01 SITE CONTEXT
AMENDMENTS MADE TO ADDRESS LRD OPINION

A S32B meeting was held on the 11th September 2025 with members of Wexford's County Council and the Design Team present. This site plan, along with supporting information, was presented at the meeting for comment. The input received from Wexford County Council resulted in the following adjustments being made prior to the final application. These amendments are addressed in the following pages.

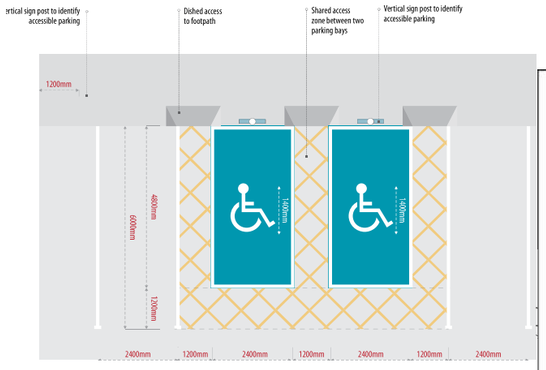
8 no. of the 103 no. communal parking spaces are dedicated to accessible parking spaces ensuring that these spaces achieve the minimum requirement of 5% accessible spaces. 6 no. EV spaces have also been provided in the form of 3 no. EV Charging Hubs.

SHARED SURFACE

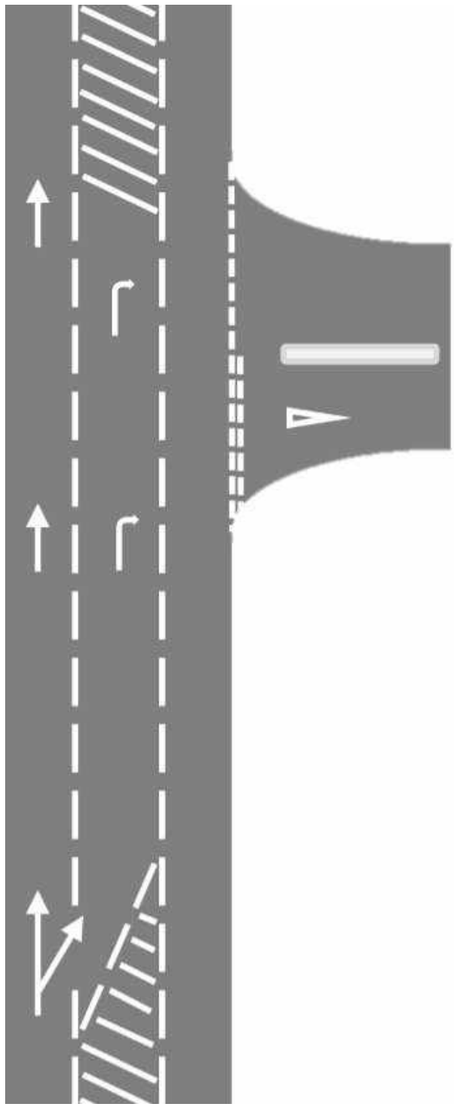
SHARED SURFACE FEATURES:

- 4.8m ROAD WIDTH
- ROAD-SIDE PEDESTRIAN PATH OR SHARED SURFACE
- PARALLEL PARKING OR ON-CUR-TILAGE PARKING
- DIRECT ACCESS TO UNITS
- INCORPORATING LIGHTING, BINS, PARKING & LANDSCAPING
